PLANNING COMMISSION PUBLIC HEARING/REGULAR MEETING CITY OF FARMINGTON HILLS OCTOBER 17, 2024 @ 7:30 P.M.

A. **ZONING TEXT AMENDMENT 2, 2024**

B. PUD PLAN 2, 2024, INCLUDING SITE PLAN 56-8-2024

SHEET
Utility Plan - East

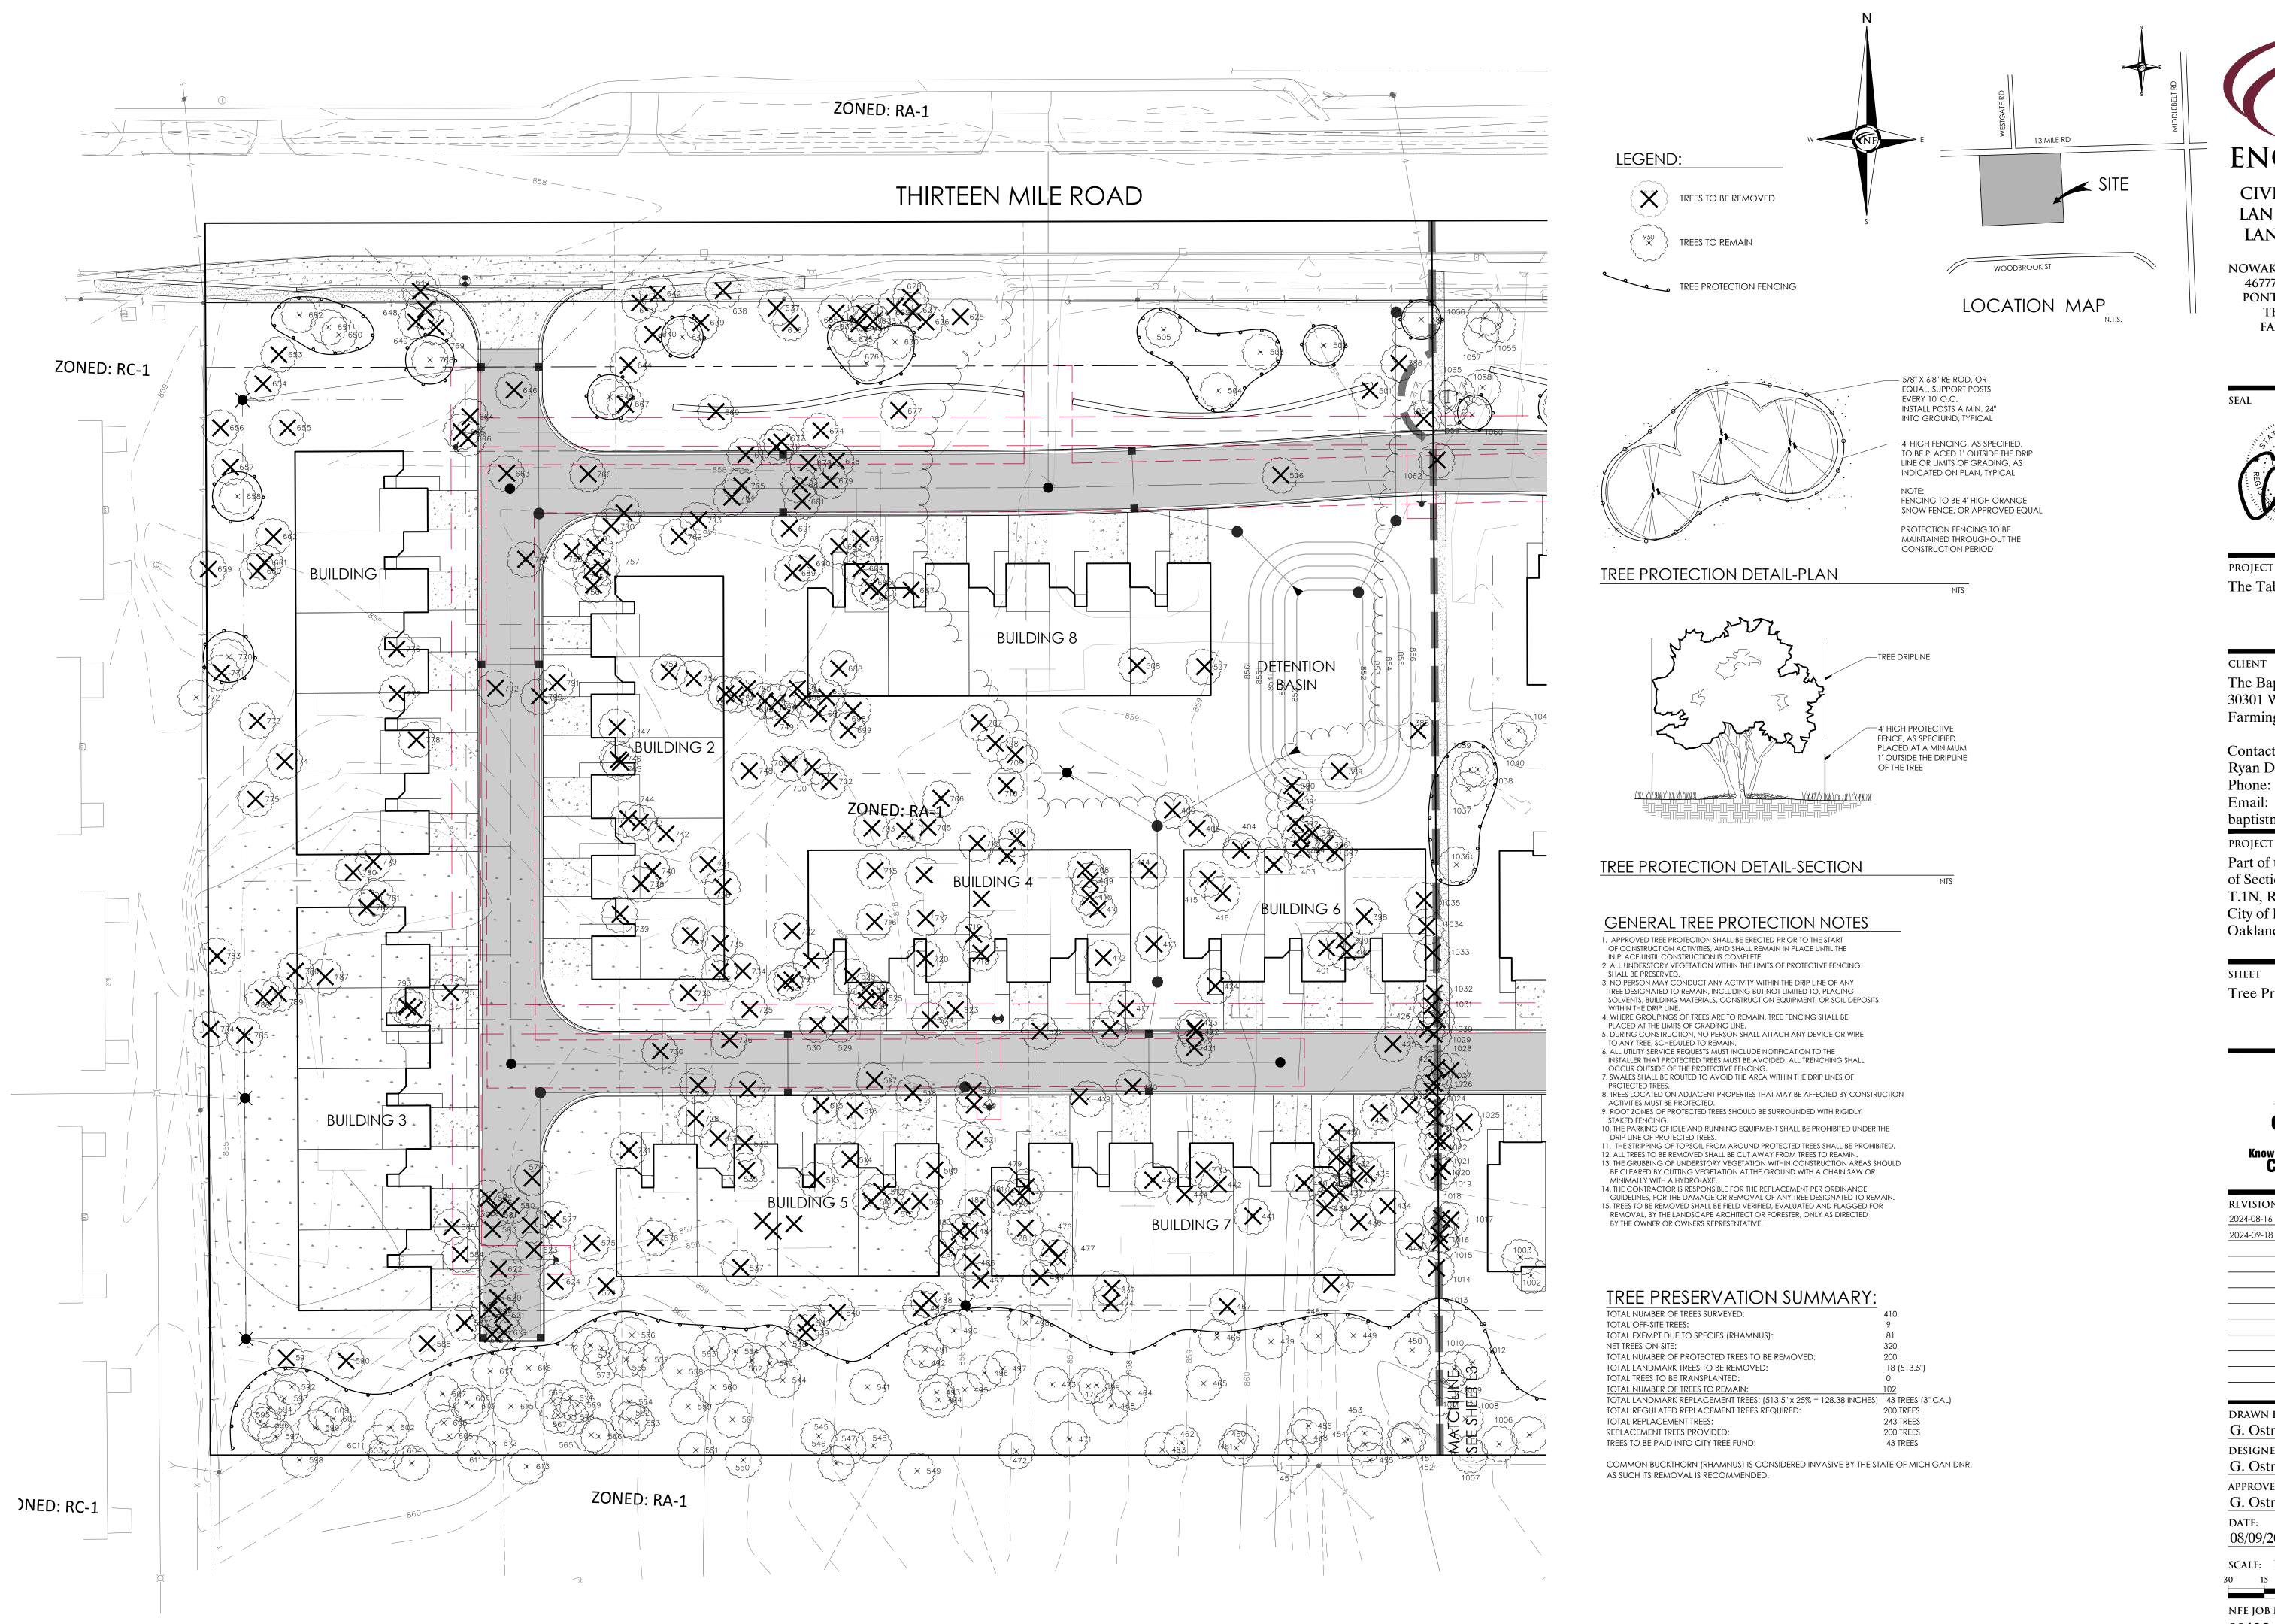
- 1. A public 10" public sanitary sewer exists on the north side of 13 Mile Road just west of Westgate Road. The proponent shows a design that will tap this system +/- 370' west of the intersection. The plan proposes to extend the public sewer throughout the site. Basement service appears to be provided. It must be confirmed. It is suggested that the public system be tapped at the manhole located at the intersection of Westmeath. Also, with the proposed sewer crossing 13 Mile Road it must be jacked and bored.

- 3. A 12" water main exists along the south side of 13 Mile Road across the frontage of the site. The plan shows two taps of this system and an internal loop. This is appropriate. Along with this design the proponent must provide an 8" public watermain stub to the east property line approximately 350' south of 13 Mile Road.

- 4. The plans imply one sewer lead and one water lead for each building. If multiple leads are being considered than taps under pavement will be an issue and the

utility design must be revised. It is suggested that all mainline utilities be placed in greenbelt areas. Taps need to be in green areas and the service lines need to be primarily identified.

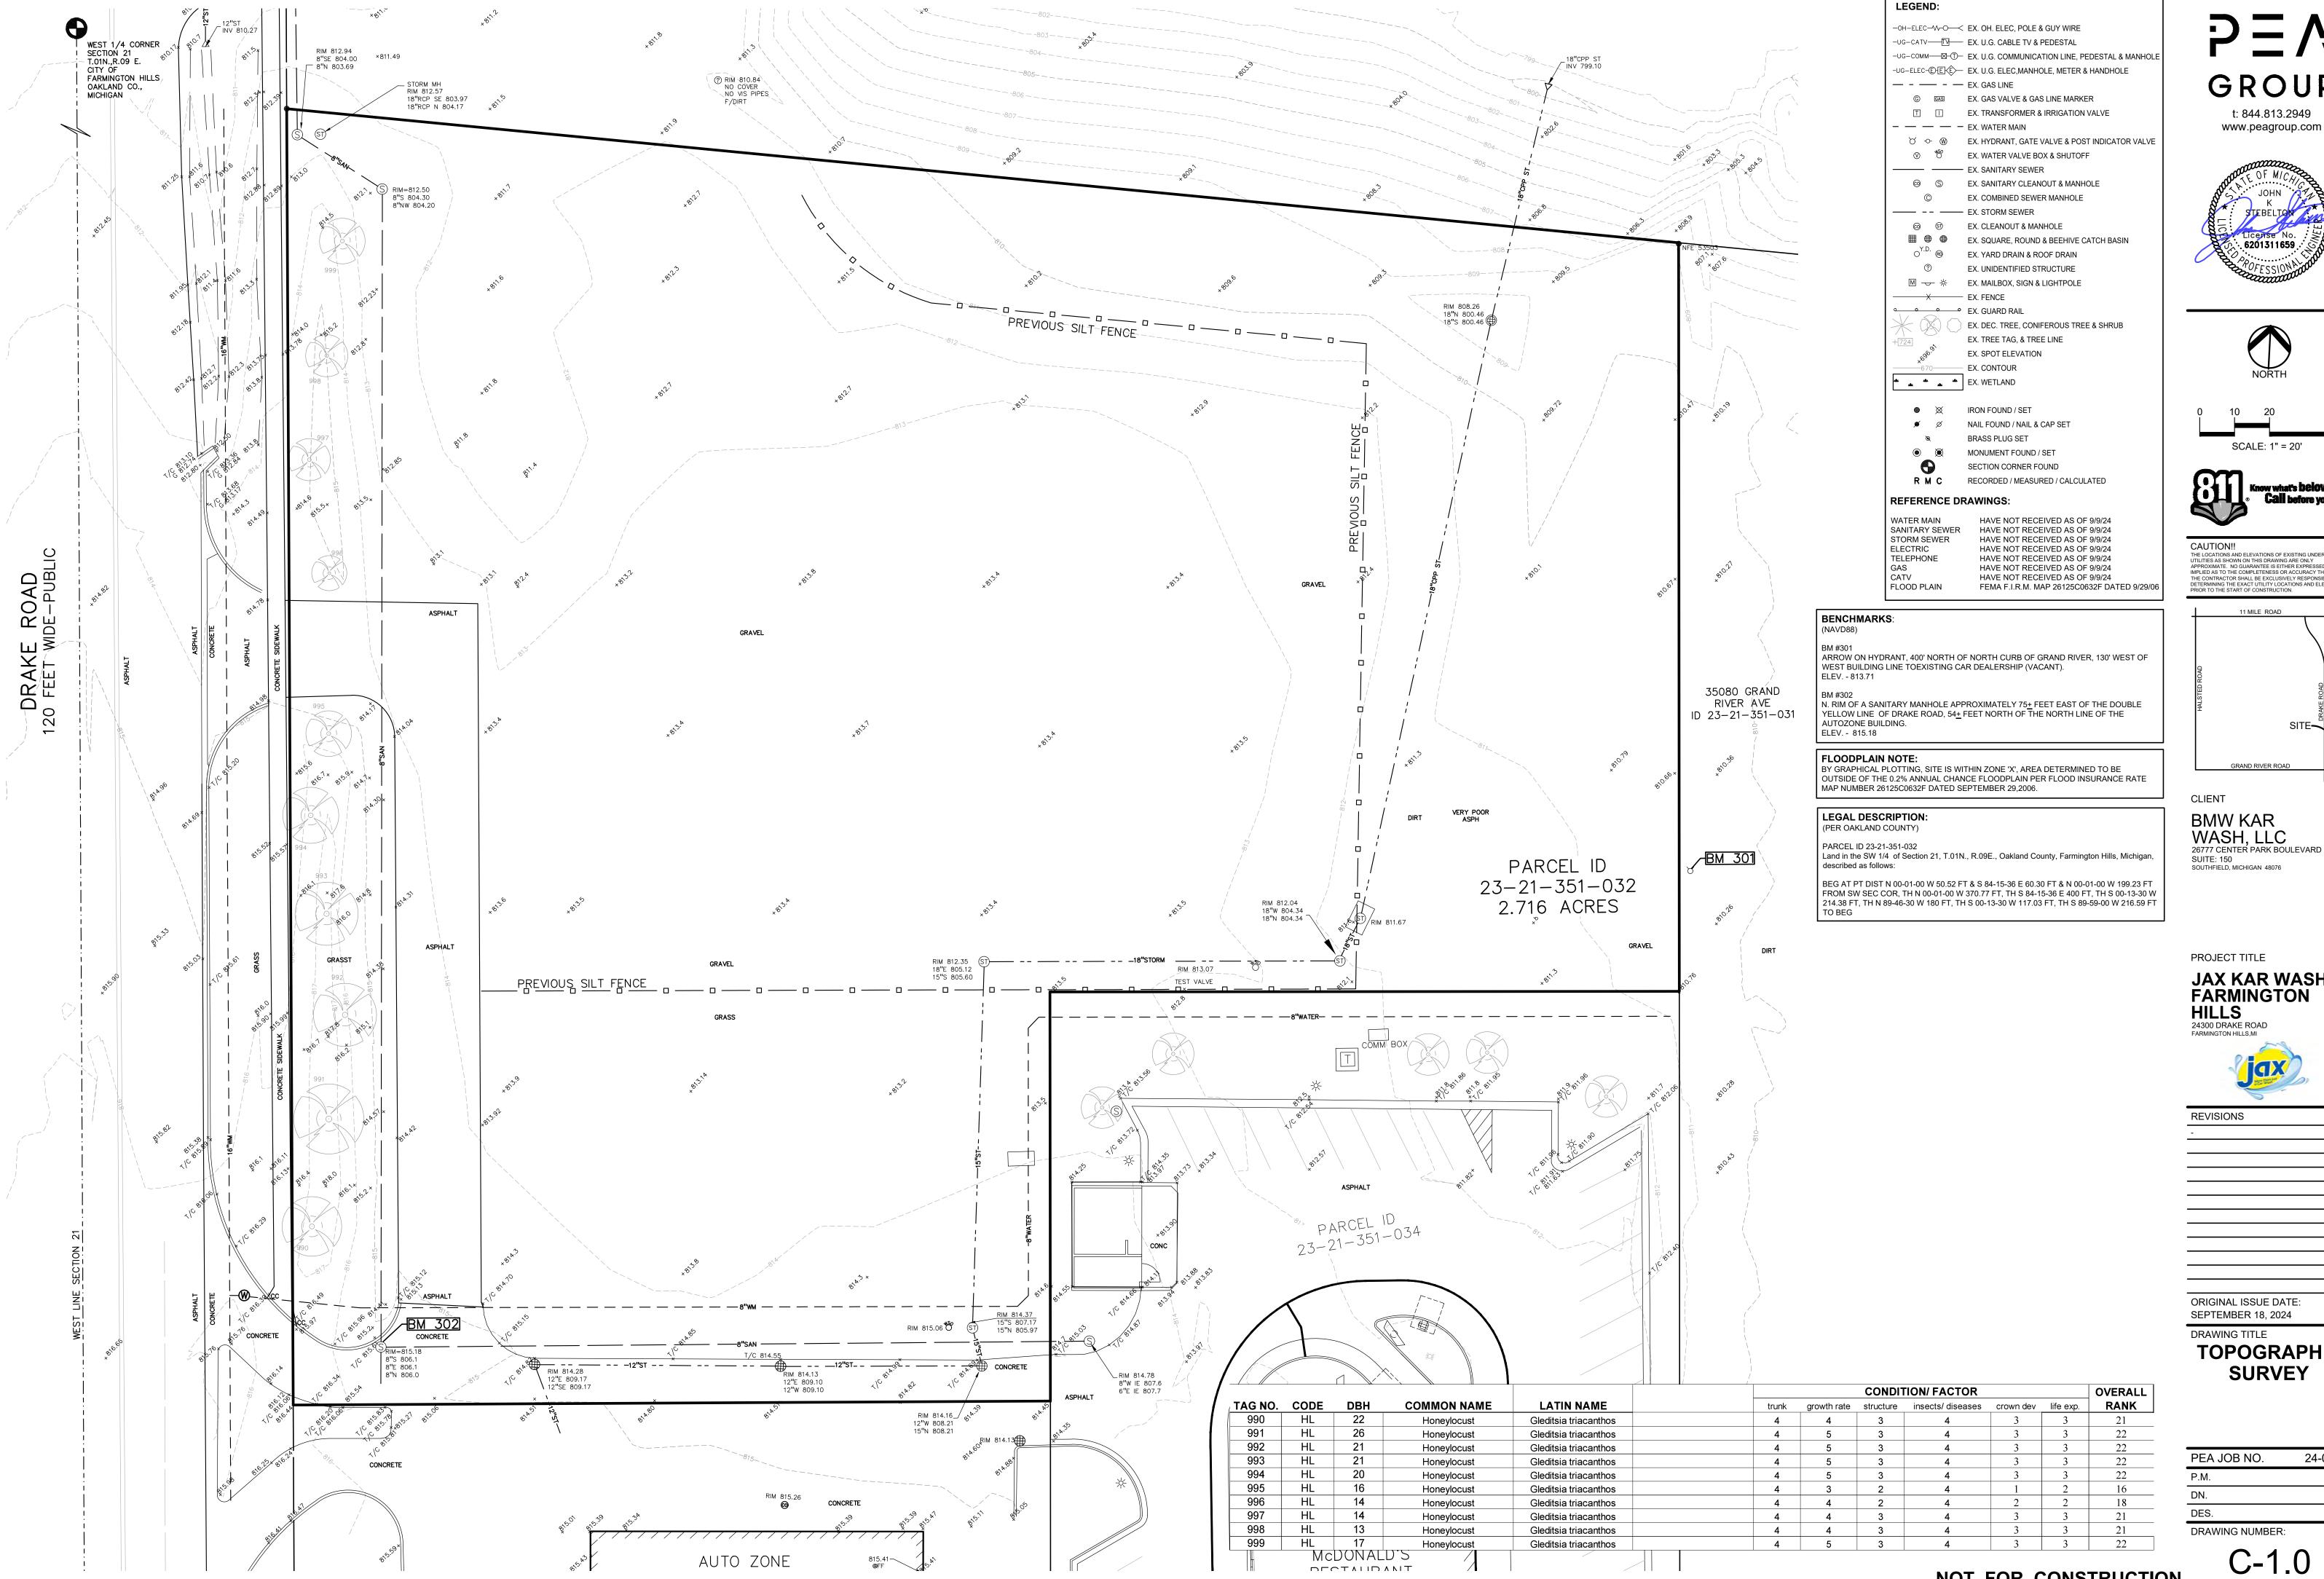
- Striping or marking shall be provided to distinguish the drive-thru lane
- Sheet C-4.0 Shows ingress stacking spaces, but the two required egress spaces beyond the washing bay shall also be included.
